Southern California Edison
2026-WMPs – 2026-WMPs

DATA REQUEST SET O E I S - P - W M P _ 2 0 2 5 - S C E - 0 0 4

Screen shots below show the 2024 overall QC inspection results for trees inspected¹.

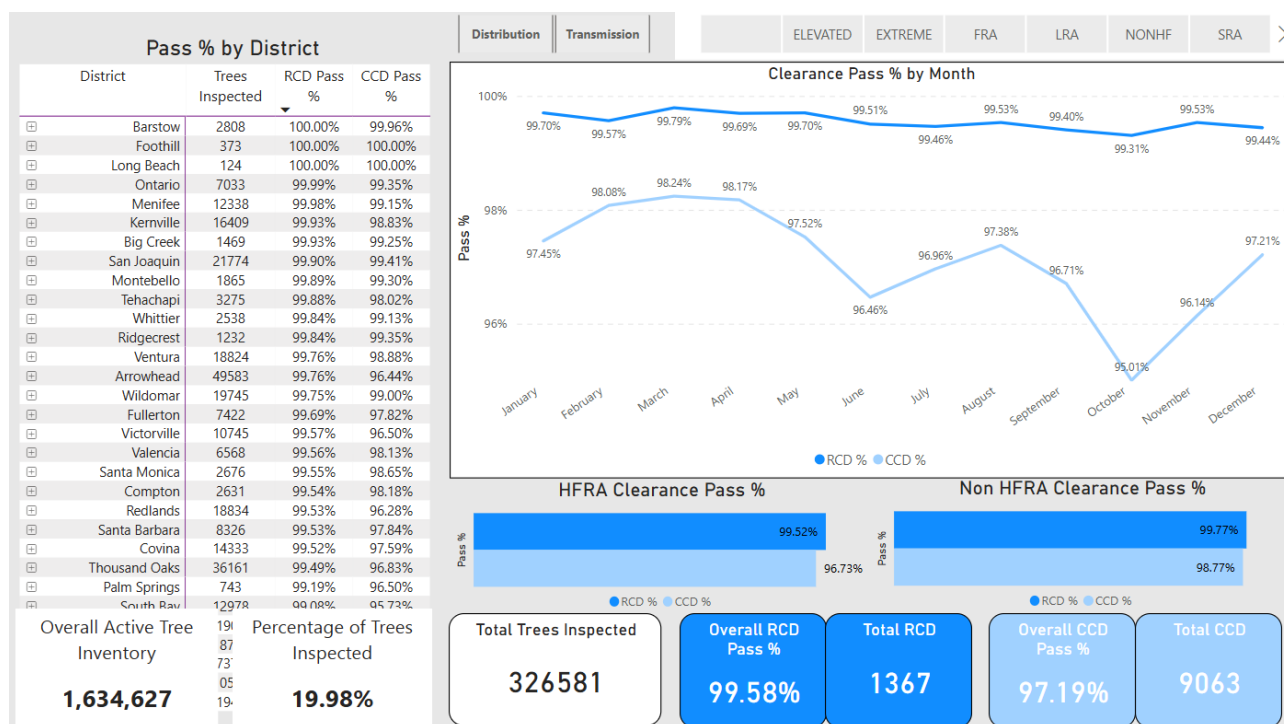
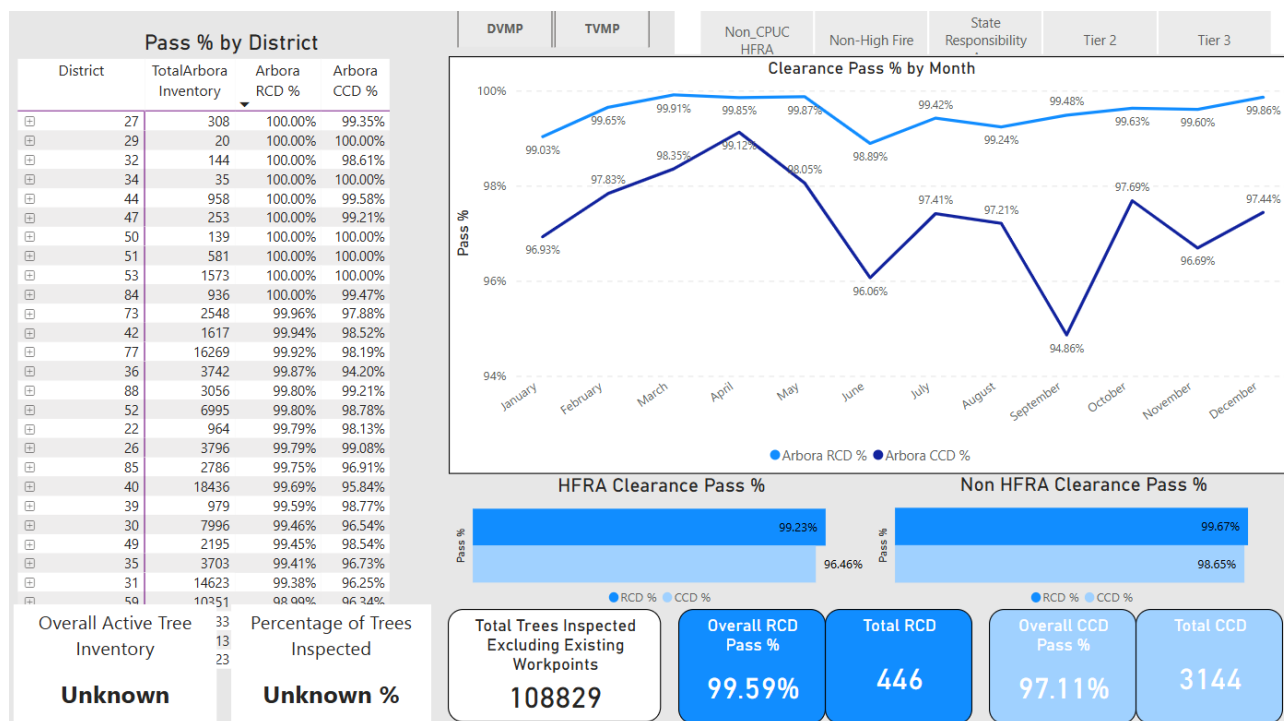
- a. Clarify if the population/sample unit is circuit miles or trees for VM-7 and VM-8.
- b. If the population/sample unit is a single tree that "passes or fails a QC audit" estimate the quantity of trees in the population and sample for VM-7 and VM-8.
 - i. If "circuit mile" is the population/sample unit, indicate how SCE calculates the pass rate at the circuit mile level based on individual tree pass/fail data.

- a. Population size for VM-7 and VM-8 inspections is circuit miles. For QC within the sampled circuit miles, individual trees are inspected.
- b. The explanation below is based on 2024 inspection quantities:
 - 5,582 HFRA miles were inspected (5,064 in Distribution and 518 in Transmission)
 - 2,898 non-HFRA miles were inspected (2,585 in Distribution and 313 in Transmission)
 - Trees are inspected within these sampled circuit miles. In 2024, SCE transitioned from its S123 database to Arbora. The quantities below are from both databases:
 - In S123, 32,6581 trees were inspected, with approximately 77% being in HFRA
 - In Arbora, 108,829 trees were inspected with approximately 77% being in HFRA
 - Pass rates are calculated on trees inspected

Image from S123 database

Image from Arbora database²² Due to database transition, overall active tree inventory and percentage of trees inspected is not calculated

4.9 Debris Clean-up & Disposal

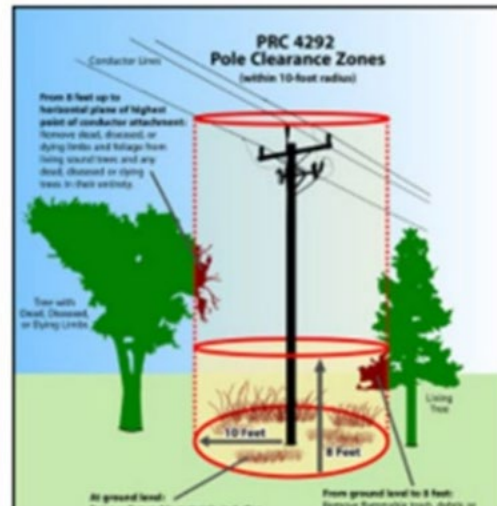
- a. Provide SCE’s Statement of Work document referenced on this page of the WMP.
- b. Explain how SCE ensures that its contractors abide by the requirements of SCE’s Statement of Work as it relates to the management of downed wood and slash generated from vegetation management activities.

Please see images below for excerpts from SCE’s Statement of Work (SOW) requiring contractors to properly cleanup and dispose of vegetation debris.

Contractor is responsible for immediate cleanup and disposal of all debris generated from line clearing or other Edison support or vegetation management activity. Contractor shall leave the property in the same condition as it was when they entered the property.
